**Subject:** RE: NYM/2021/0999/FL

**SPECIFICATION FOR THE REMEDIATION OF AN EXISTING GABION BASKET WALL**

**THE TEA HUT, ROBIN HOOD'S BAY**

# Revised Proposal – Cliff Stabilisation and Proposed Extension to The Galley on the Quarterdeck

1:100 SCALE, AT A2 SIZE  
 Unit 34b, Welton Business Park, Wiske Avenue,  
 Brough, East Yorkshire, HU15 1ZQ  
 Client: GHYLLWOOD DEVELOPMENTS Ltd Date: 7-12-21  
 Project: Tea Hut extension Scale: 1:100  
 Site: 'The Quarter Deck' ROBIN HOODS BAY Drg.No. 3029-2 A

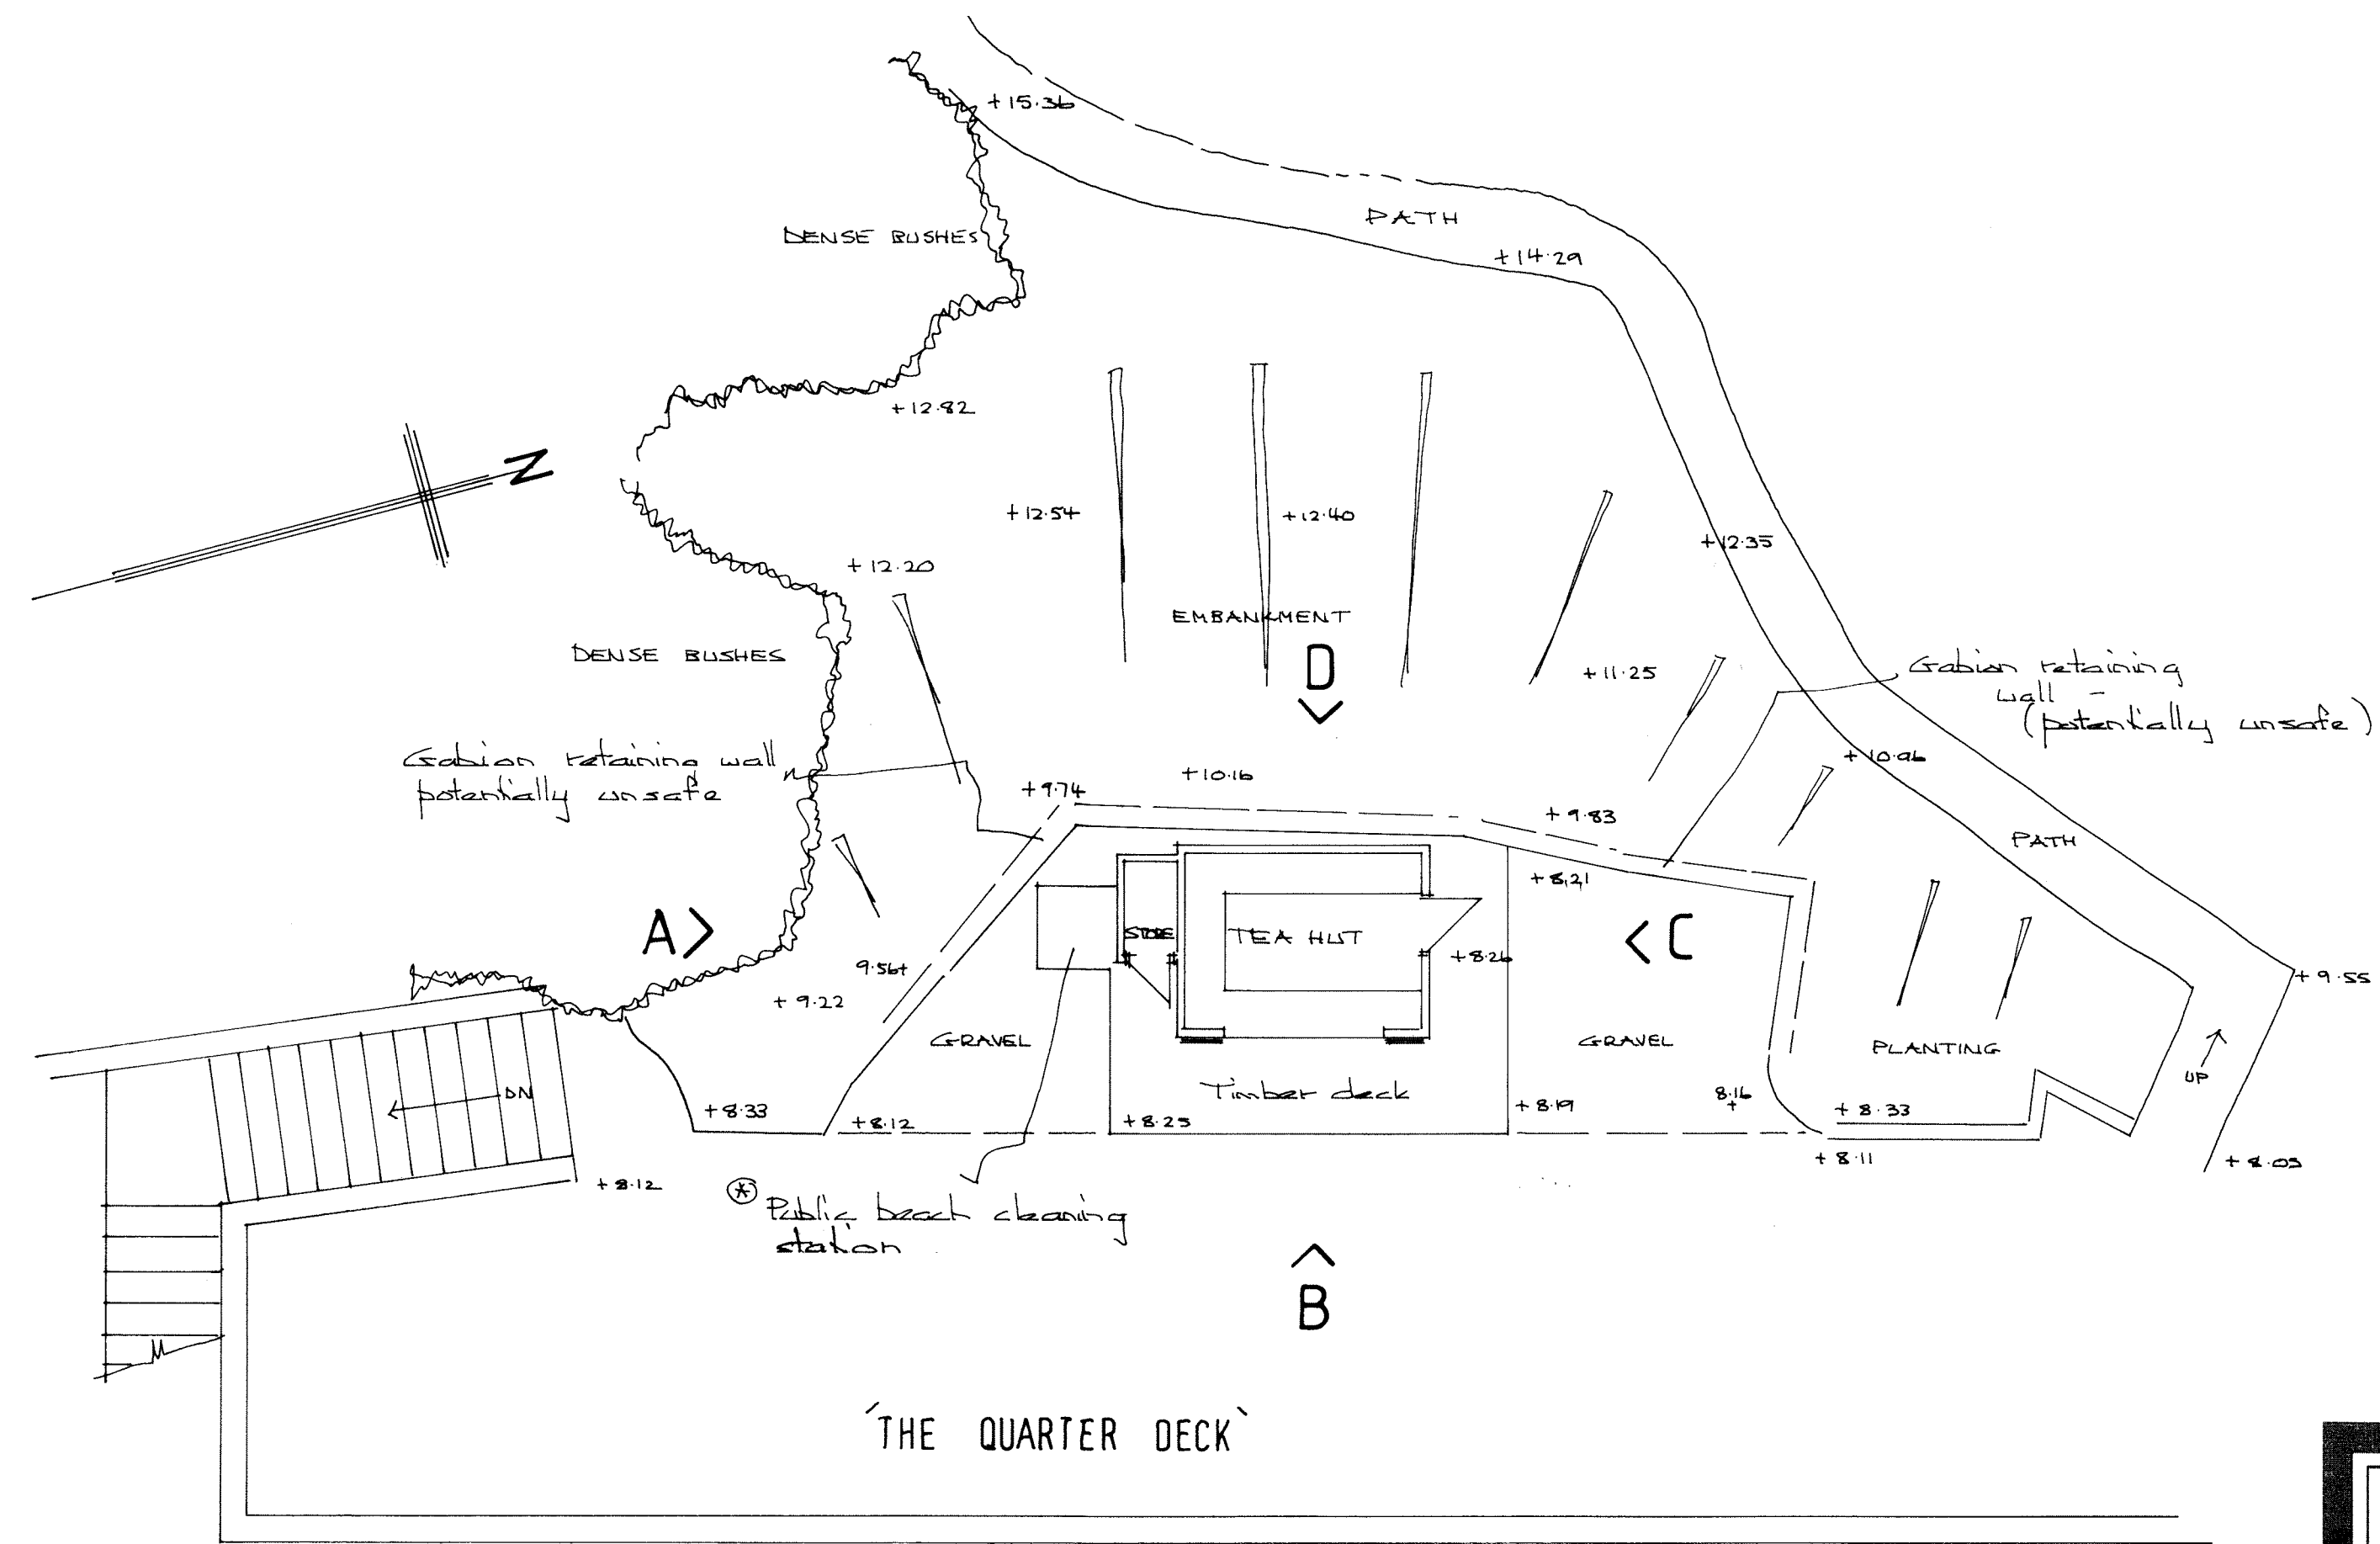
REV A : DRAWING REVISED TO SIDE EXTENSION 9-5-22

Proposed site layout plan 1:100 SCALE

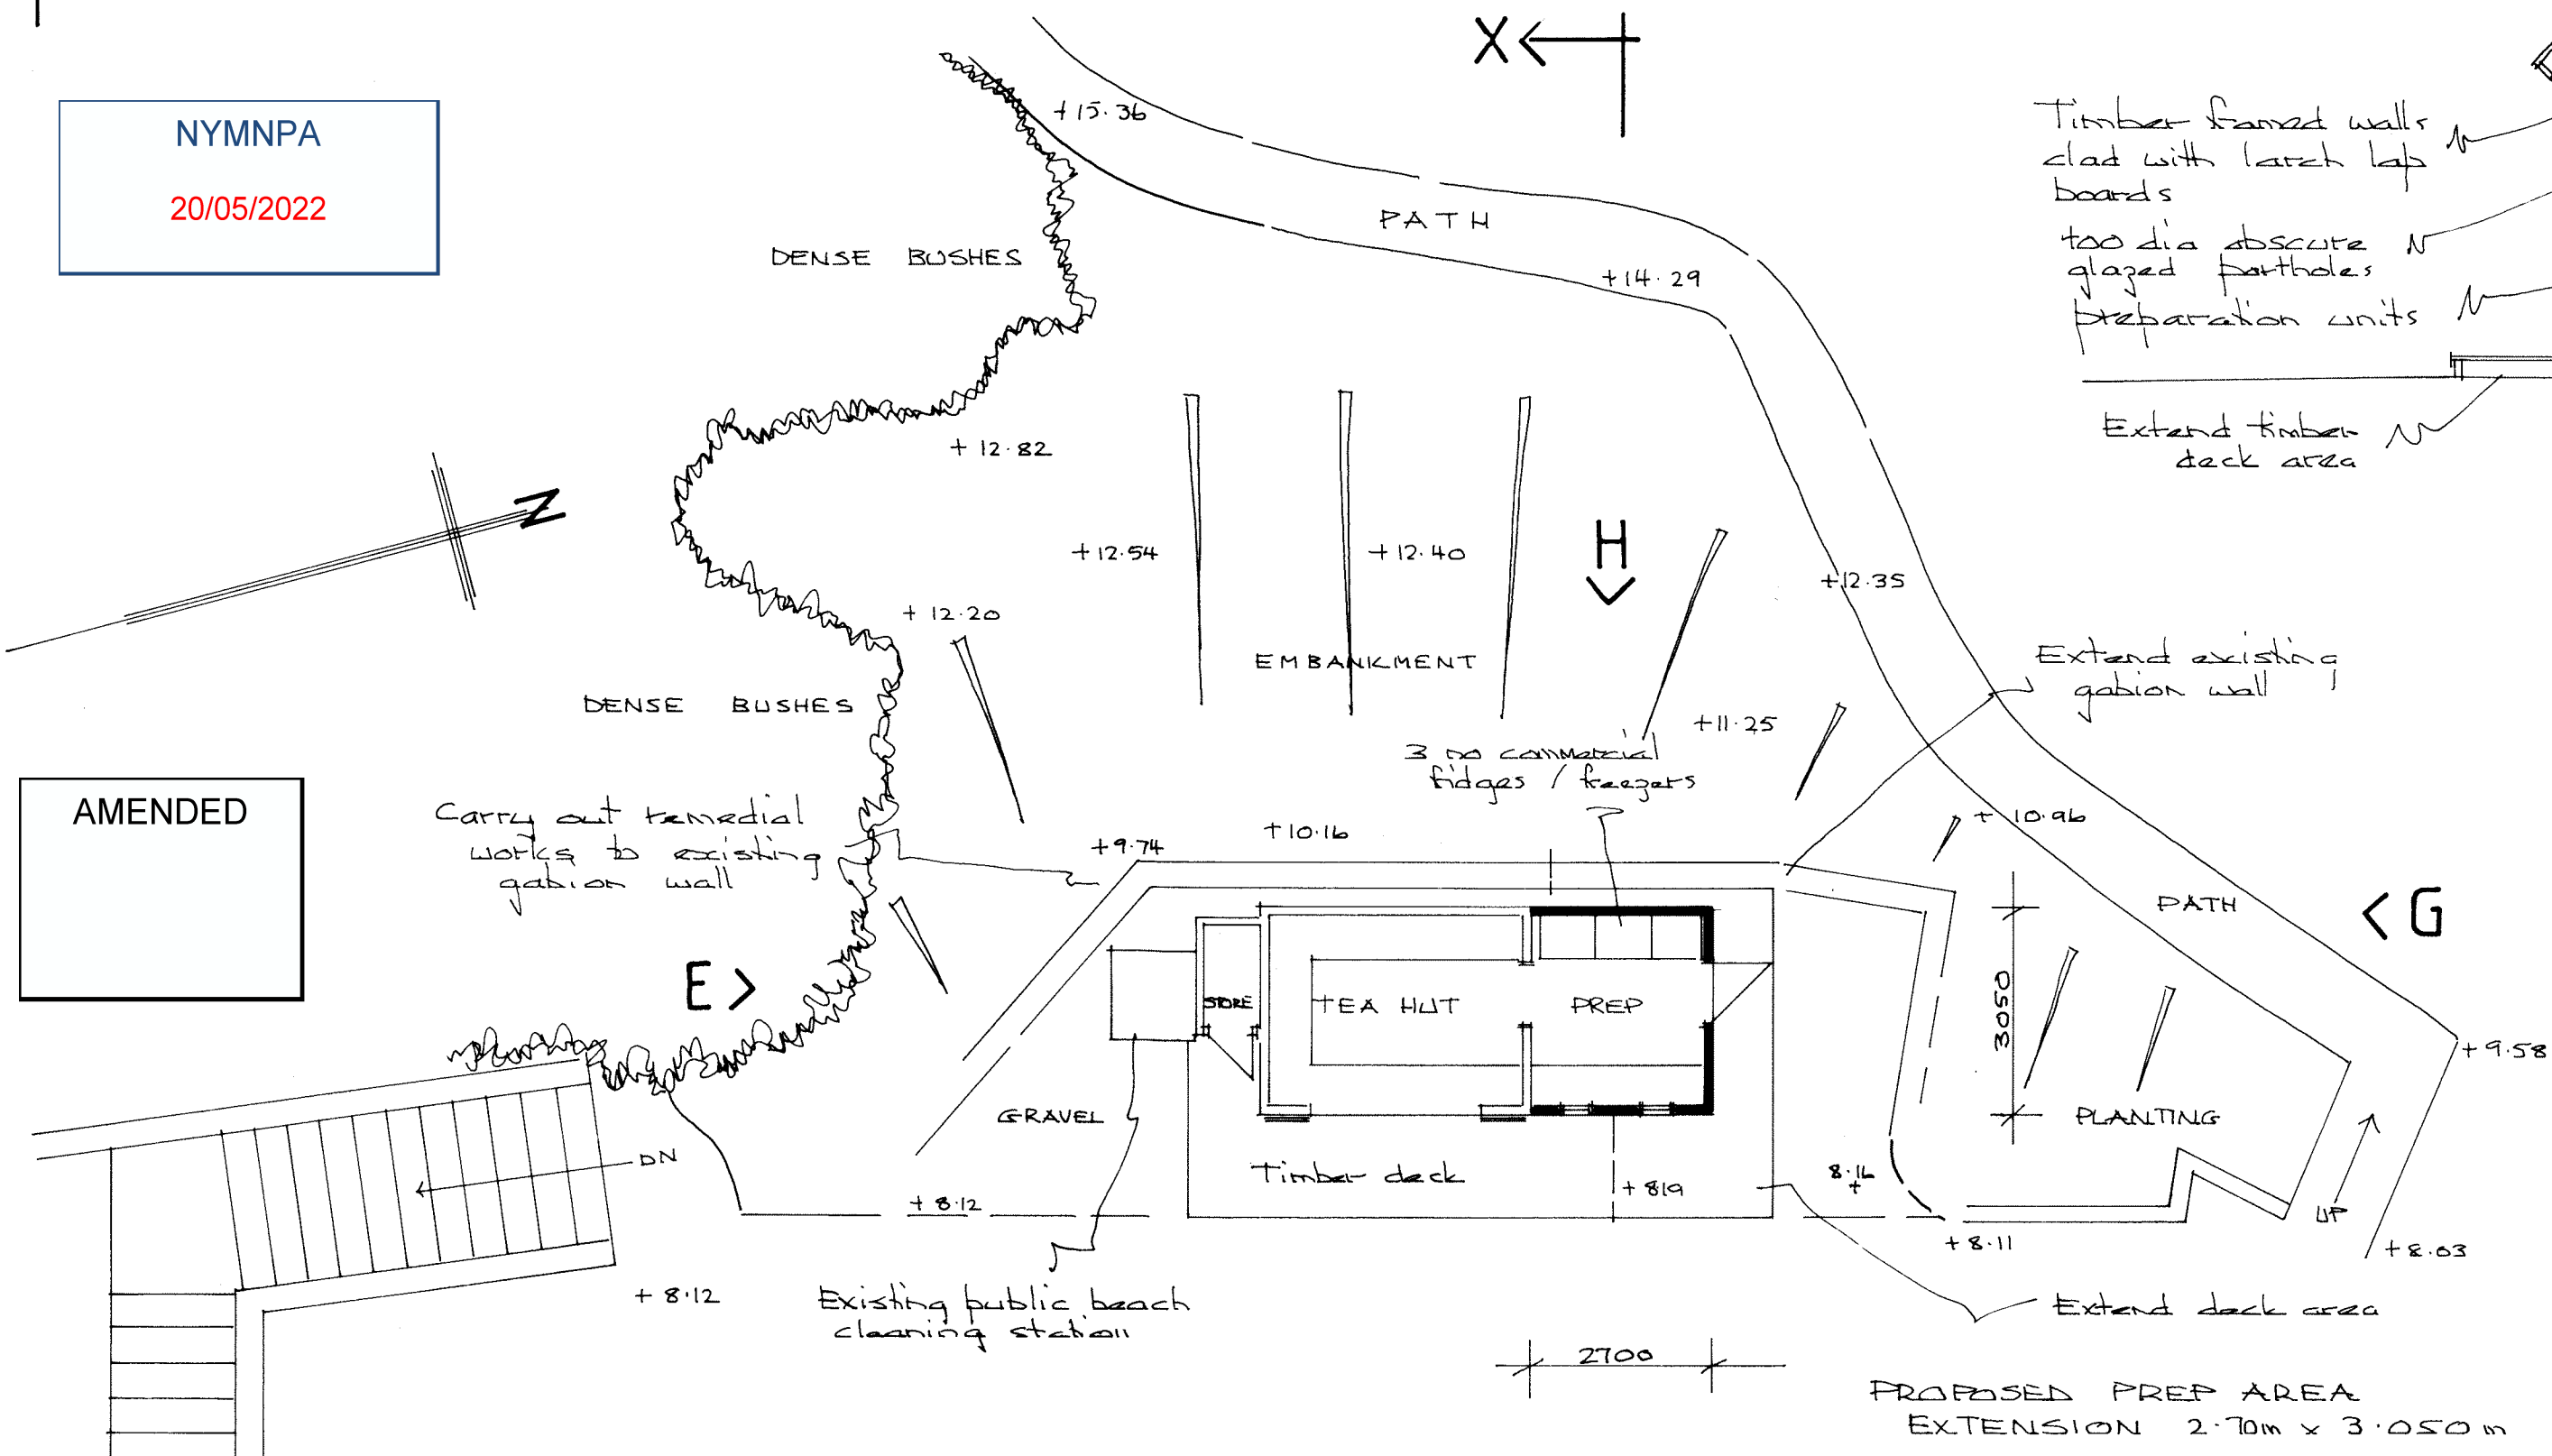
The proposed extension has been greatly reduced and repositioned, from the original 6m wide in-cliff structure, behind, to a modest 2.5m wide extension to the right-hand side. All materials will be identical to and mirror the existing.
